The U.S. Environmental Protection Agency (EPA) has reviewed the Navy's draft *Parcel G Removal Site Evaluation Work Plan, Former Hunters Point Naval Shipyard*, San Francisco, California, June 15, 2018 (*Work Plan*). EPA acknowledges that the need for this Work Plan is due to a highly unusual and serious situation. It is for this reason that EPA and California Department of Toxic Substances Control (DTSC) wrote the Navy in 2016 to reiterate our agreement with you that no further transfers of property should occur until we fully investigate our concerns regarding all data collected by Tetra Tech EC Inc. At the same time, EPA stressed that retesting in locations of greatest concern should take place as soon as possible.

**EPA Review of the June 15, 2018, Draft *Parcel G Removal Site Evaluation Work Plan*,
Hunters Point Naval Shipyard, San Francisco, California
EPA Review dated August 14, 2018**

SUBJECT: FINAL - STATISTICAL REVIEW OF UNITED STATES NAVY DRAFT PARCEL G REMOVAL SITE EVALUATION WORK PLAN, HUNTERS POINT NAVAL SHIPYARD SITE (HPNS), SERAS-106, WORK ORDER #83

Figure 1. Distribution of Ra-226 Off-Site Laboratory Measurements in picocuries per gram (pCi/g) in Background Reference Areas

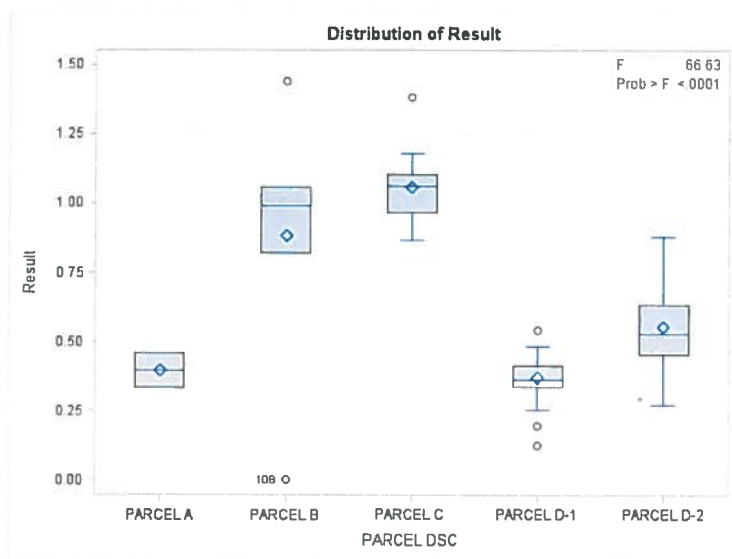
A similar evaluation must be made prior to combining surface and subsurface sample results. Appendix A of the Work Plan acknowledges the expected disparity between the RBAs and states on page 3-1 *"Collections of fallout radionuclides are variable in soil at HPNS because of deposition and erosion, and from layering and mixing during placement of fill soil. Thus the concentrations of naturally occurring ubiquitous radionuclides may vary by location and depth."* It is unclear at this time, whether stratification of the soil in Parcel G also includes stratification of ROC concentrations within the RBAs, and if combining surface and subsurface sampling results within the individual RBAs or across the combined RBAs is appropriate for comparison to the soils in the TUS and SUs.

Discussion: Unless and until evidentiary data is collected to demonstrate that sample results from the four on-site RBAs can be combined to represent one reference background population, sufficient and an equal number of samples should be collected per RBA and per soil depth (surface and sub-surface) to allow for independent comparisons with on-site data. It is already noted in the Naval Draft Work Plan that the Bayview Area represents a different distribution of ROCs than the four on-site areas. Twenty-five surface soil samples are planned for collection at the Bayview Area; an equal number should be collected from the on-site RBA's.
